Monthly Specification Update

Intel® Server Board S5520UR

Intel Order Number E69054-001

January 2012

Figure 1. Removing the Heatsink

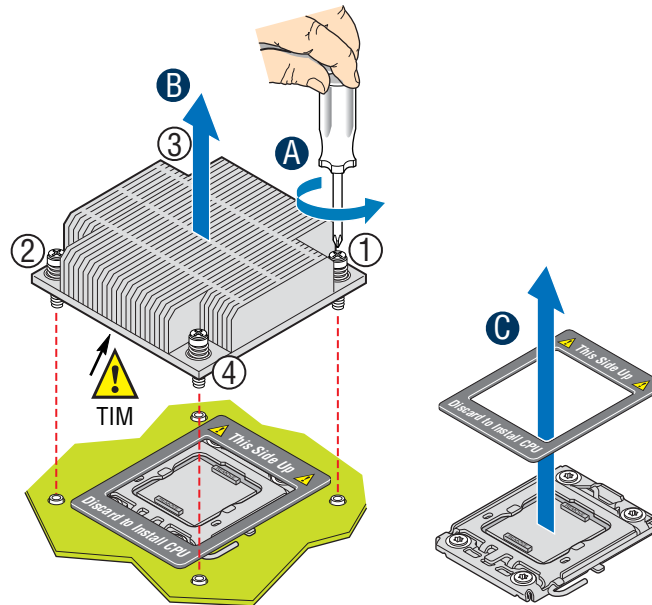
- Problem:** The current documentation does not properly describe the installation and removal of the heatsink. Careful insertion and removal of the heatsink is required to prevent damage to the heatsink screws or backplate.
- Implication:** There is a possibility of damage to the heatsink if proper steps are not followed.
- Status:** Corrections incorporated into the latest version of the following Service Guides:
- Intel® Server System SR1600 Service Guide (Intel Order Number: E52880-003)
 - Intel® Server System SR1625 Service Guide (Intel Order Number: E52881-003)
 - Intel® Server System SR2600/SR2625 Service Guide (Intel Order Number: E51243-003)
- Workaround:** Perform the steps outlined below for installation and removal of the heatsink to avoid damage.

1. Loosen the four captive screws on the heatsink corners in a diagonal manner according to the numbers shown in figure 1 as follows:
 - Starting with the screw at location 1, loosen it by giving it **two rotations** in the anticlockwise direction and stop. (**IMPORTANT:** Do not fully loosen.)
 - Proceed to the screw at location 2 and loosen it by giving it two rotations and stop.
 - Loosen screws at locations 3 and 4 by giving each screw two rotations and then stop.
 - Repeat steps 1a through 1c by giving each screw two rotations each time until all screws are loosened.
2. Do one of the following:
 - If removing the heatsink for the first time, do the following:
 - i. Lift the heatsink from the board.
 - ii. Remove and discard the spacer (see letter “C” in figure 1).

- If a processor is already installed, do the following:
 - i. Twist the heatsink slightly to break the seal between the heatsink and the processor.
 - ii. Lift the heatsink from the processor. If it does not pull up easily, twist the heatsink again. Do not force the heatsink from the processor. Doing so could damage the processor.
